OFFICIAL STAR CLASS MEASUREMENT CERTIFICATE

YACHT NO. 3214

Report from International Measurement Committee

Concerning meas.cert. 3214

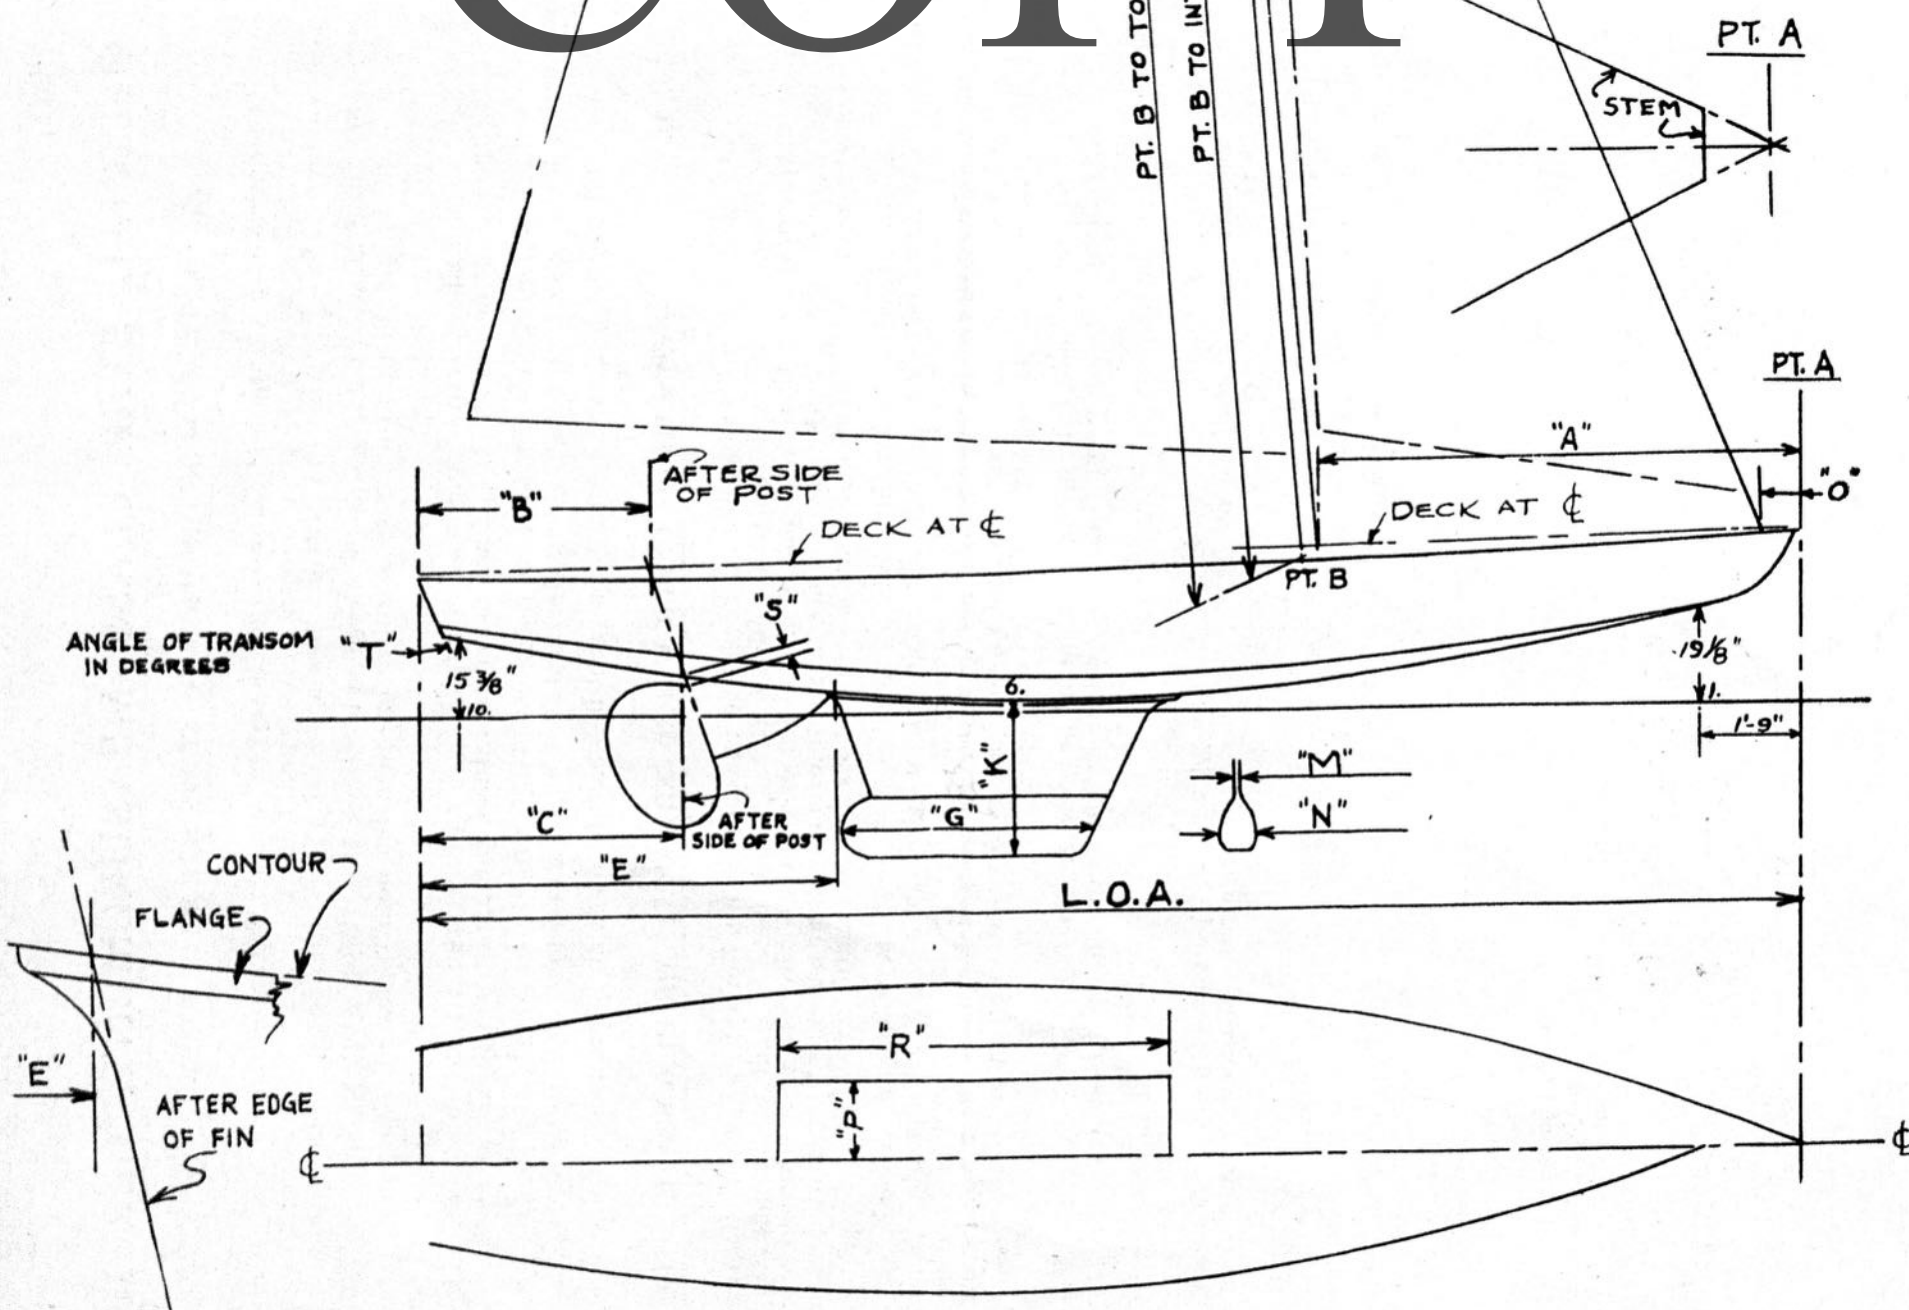
IT APPEARS THAT HALF CORRECTION AT 3
AND HALF CORRECTION AT 3 WERE
REVERSED WHEN MAKING UP THE FORM J. IS
THIS THE CASE?
(FORM J SHOWS CORRECTION AT 3-602

Dimens. B was an writing error

Dim. B is 1,154 m ✓
=====

(formerly 1,540) wrong)

Half breadth a Deck station 3 60.2 ✓

" chine " 40.00 ✓

The corrections have
been made as noted in the memo.
